Dean Moor Solar Farm

Environmental Statement: Appendix 7.8 – Arboricultural Impact Assessment

Deadline: 2

Revision: ~~21~~

Rev: A

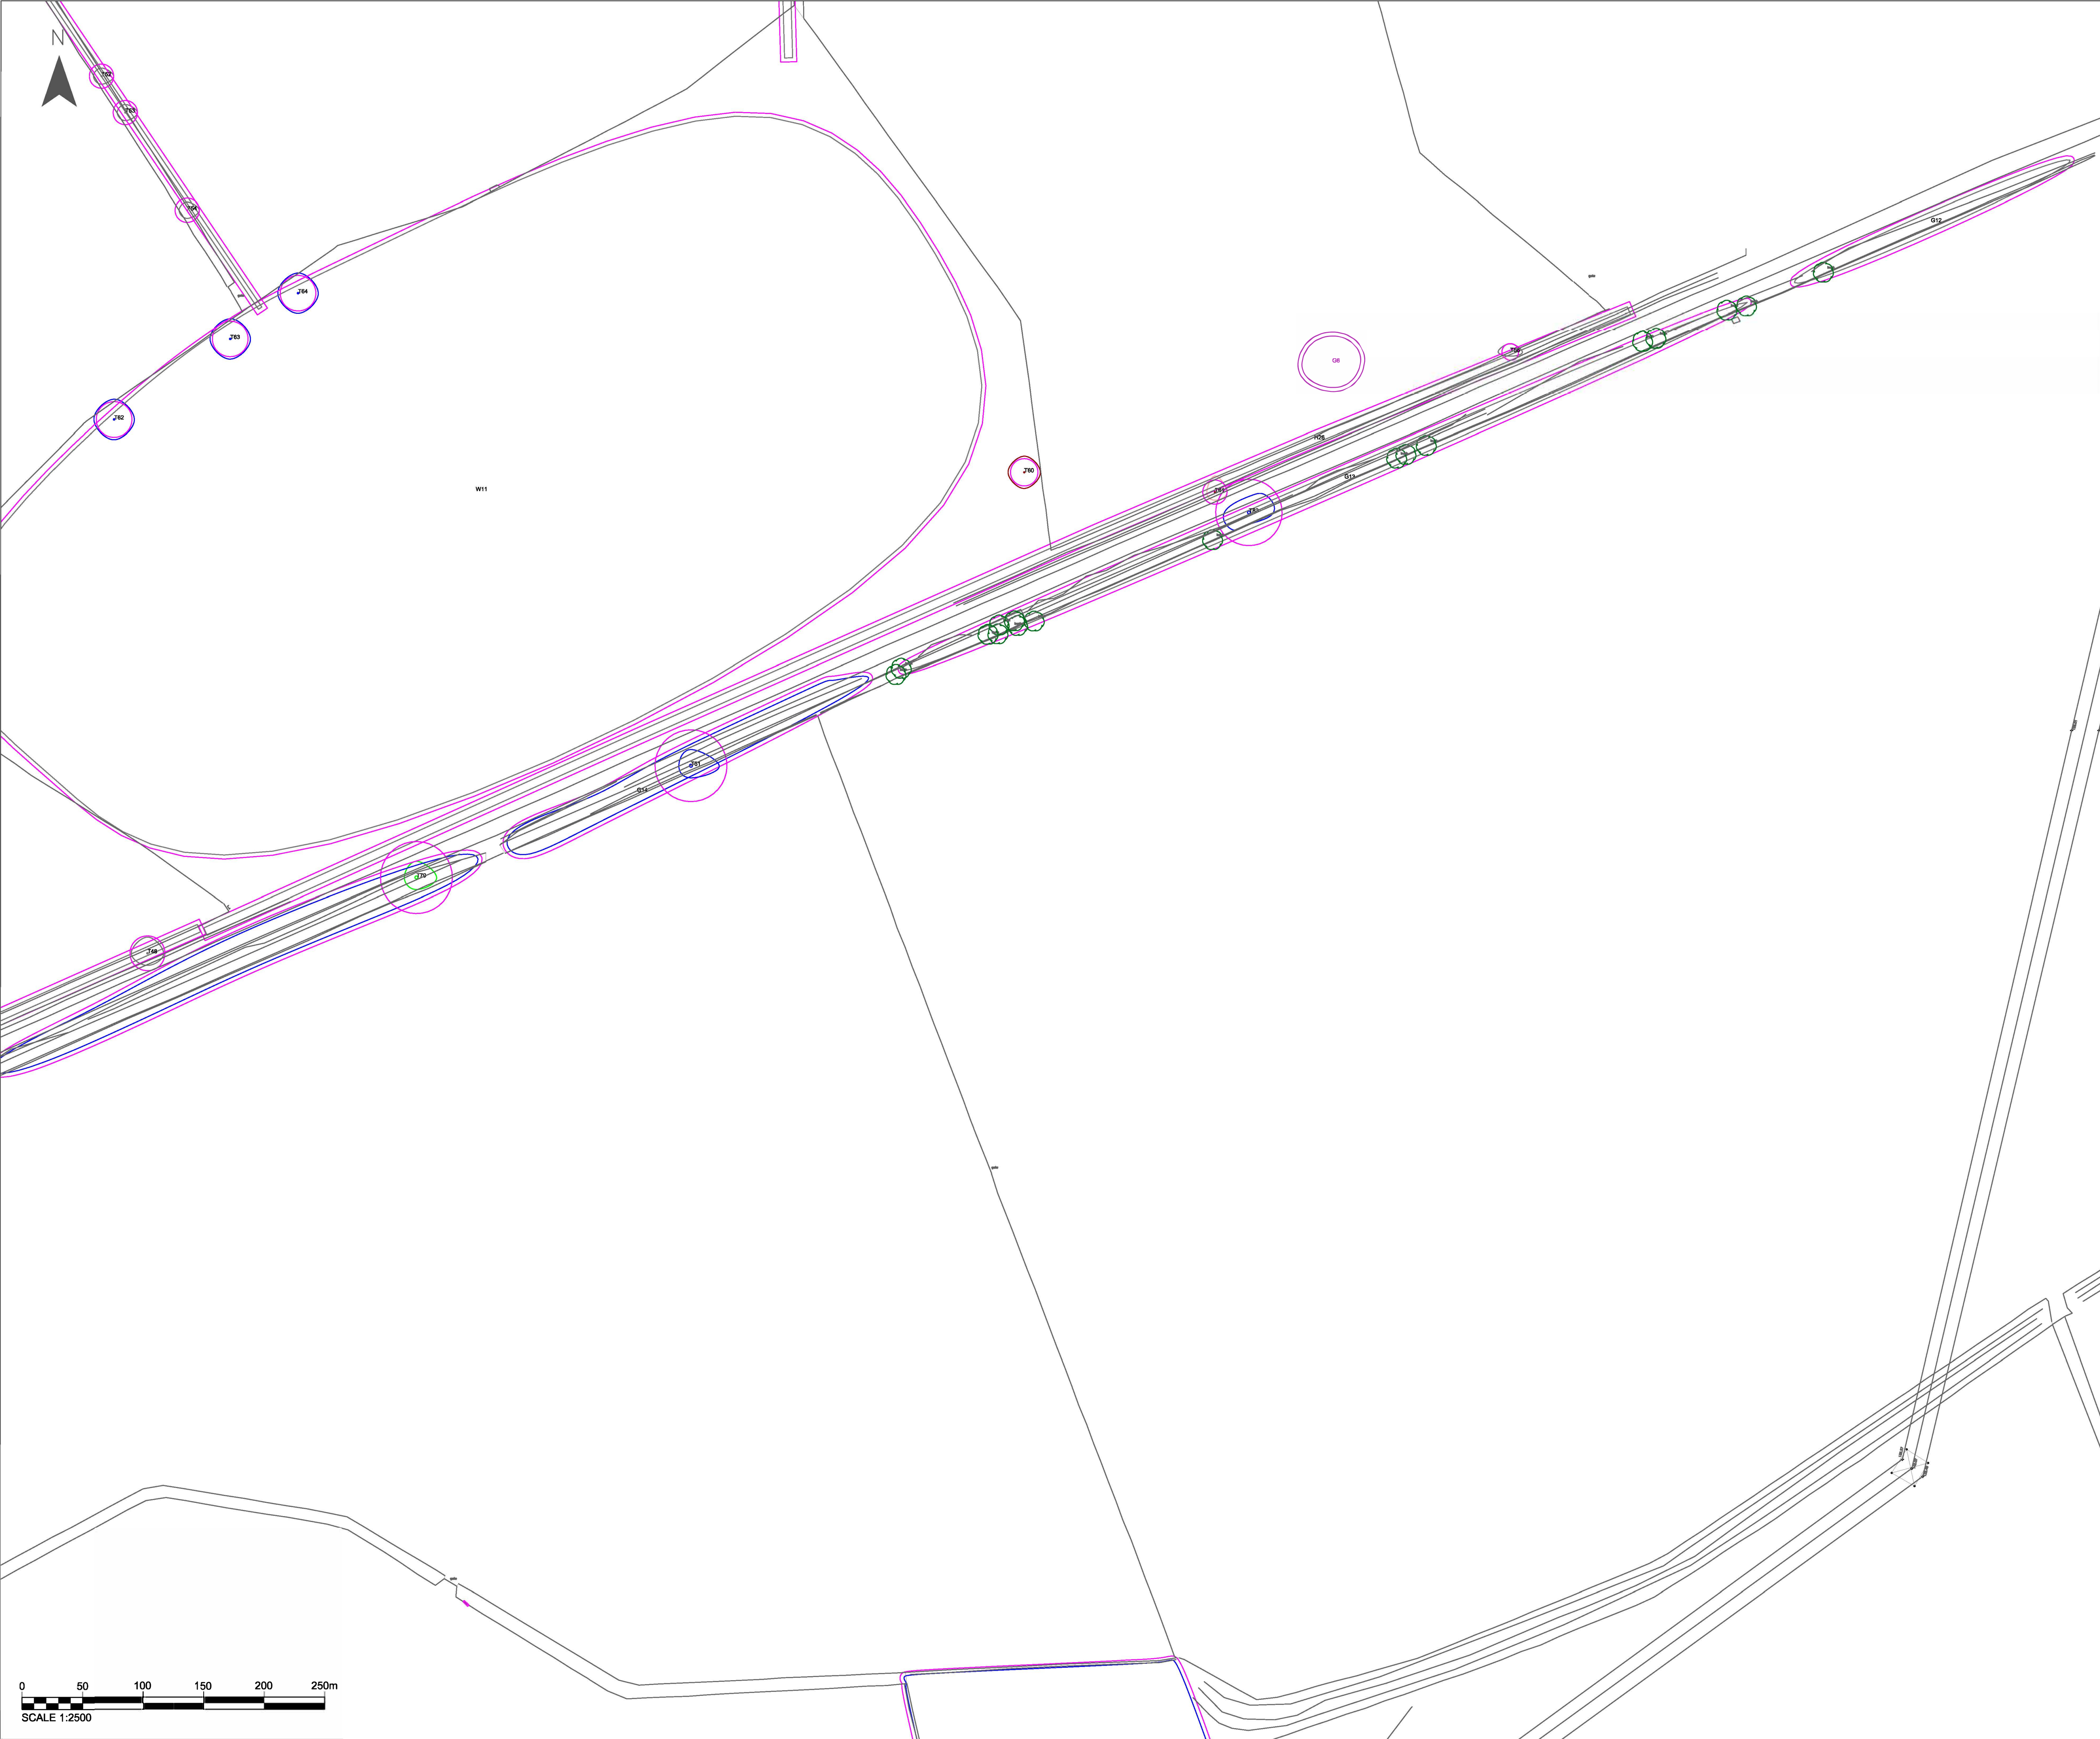
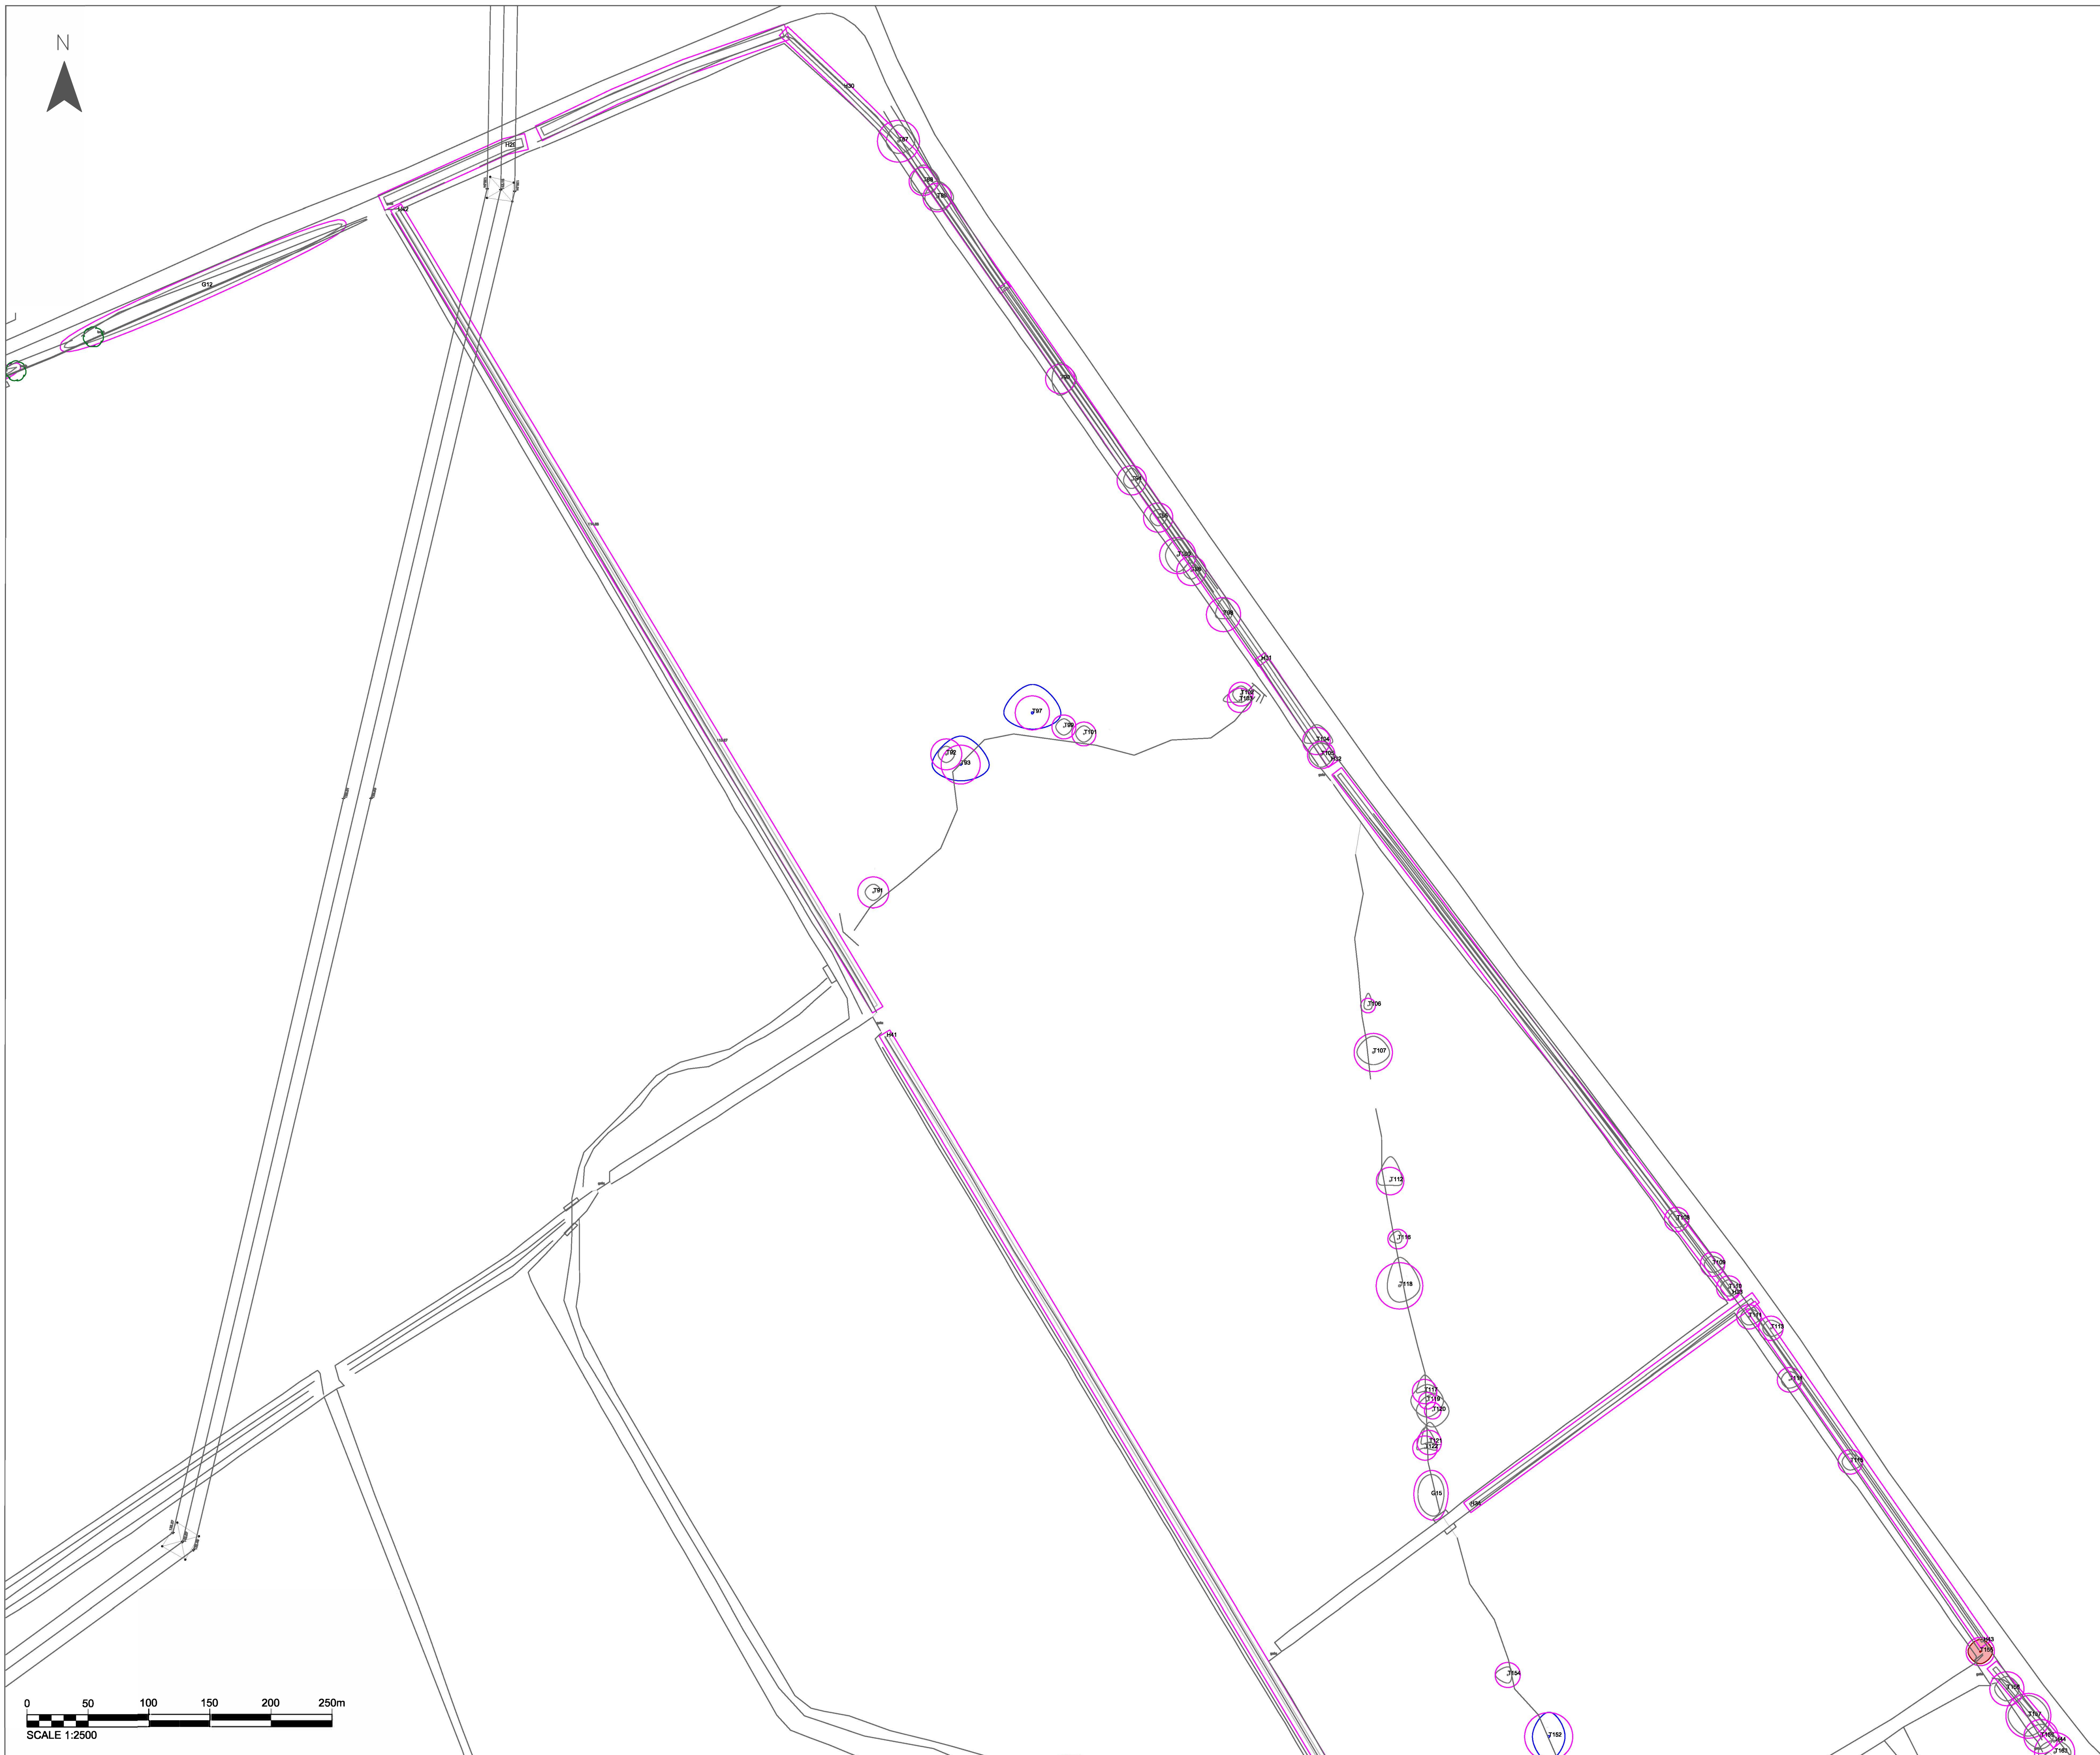
Revision	Reason
Change of the plan title in the TCP from 'Location Plan' to 'Tree Constraints Plan'	To make it clear that the plan is displaying the TCP. As the Location Plan is a different figure within the ES.
A renumbering of the sheets included in the TCP. Changing the order from 0-22 to 1-23.	To enable the first sheet within the TCP is numbered 1 rather than 0.
Change of the plan title in the TPP from 'Location Plan' to 'Tree Protection Plan'	To make it clear that the plan is displaying the TPP. As the Location Plan is a different figure within the ES.
A renumbering of the sheets included in the TPP. Changing the order from 0-22 to 1-23.	To enable the first sheet within the TPP is numbered 1 rather than 0.
